# UNITED STATES PATENT AND TRADEMARK OFFICE

APPLICATION NO.	FILING DATE	FIRST NAMED INVENTOR	ATTORNEY DOCKET NO.	CONFIRMATION NO.
10/817,055	04/02/2004	Yves R. Hoarau	HOARAU-01	2228

## Office Action Summary

## DETAILED ACTION

FIG. 8

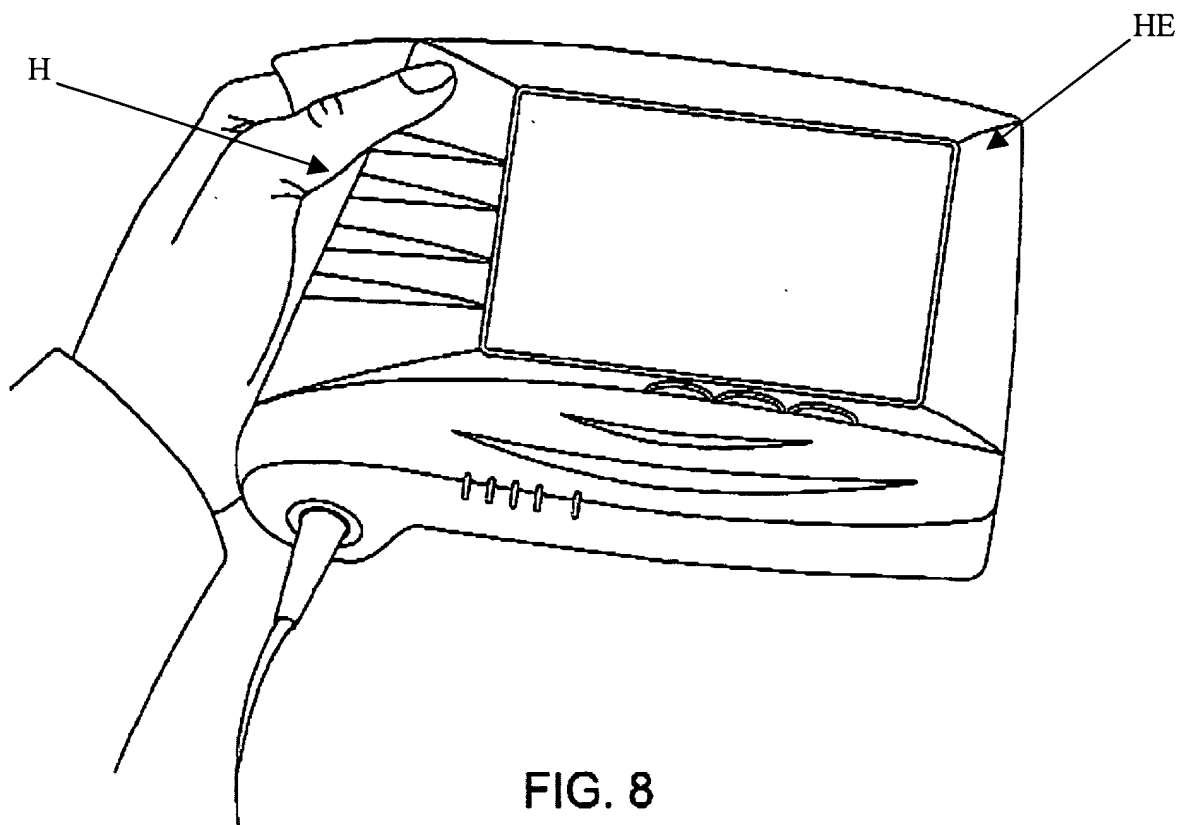
As to claims 2,5,9,13, and 48 Barnes et al disclose the claimed invention except for the discoid head. It would have been an obvious matter of design choice to manufacture the head of the device having a discoid shape, since such a modification would have involved a mere change in the shape of a component. A change in shape is generally recognized as being within the level of ordinary skill in the art. Further to claim 9, head (118) obviously has a first and second parallel flat surfaces, otherwise display (110) would be held in a slanted orientation.
